FUSE—WINDSHIELD WIPERS—BLOWS IN FREEZING TEMPERATURES

Article No.
93-20-7

MERCURY: 1991-1993 CAPRI

Figure 1 - Article 93-20-7

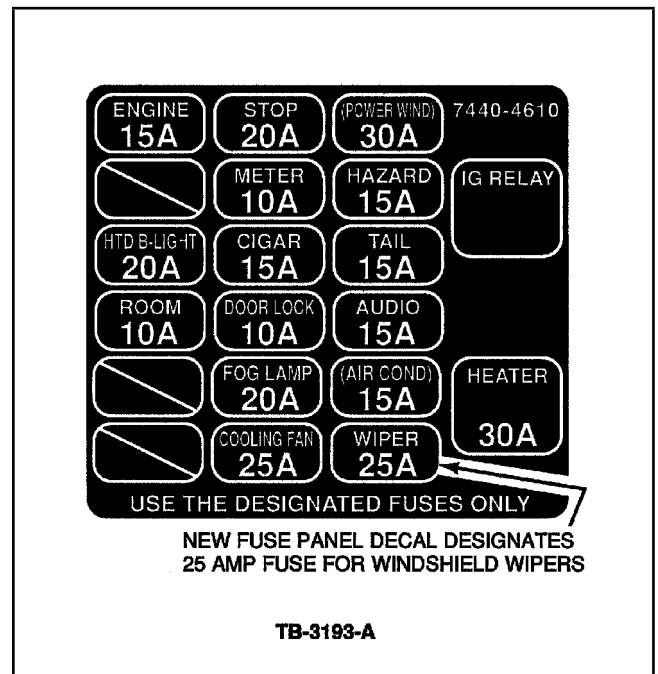
The “wiper” fuse may electrically blow when attempting to operate the windshield wipers while the wipers blades are frozen to the glass.

1. Replace the “wiper” fuse (15 amp or 20 amp) with a 25 amp fuse (D9ZZ-14526-F).
2. Replace the interior fuse panel decal with a new decal (F1JY-14A003-A) which designates a 25 amp fuse for the windshield wipers, Figure 1.

THE NEW FUSE PANEL DECAL ALSO DESIGNATES A 25 AMP FUSE FOR THE COOLING FAN. ENSURE THAT THE VEHICLE HAS BEEN FITTED WITH A 25 AMP COOLING FAN FUSE OR UPGRADE AS REQUIRED (REFER TO TSB 92-7-7 FOR DETAILS).
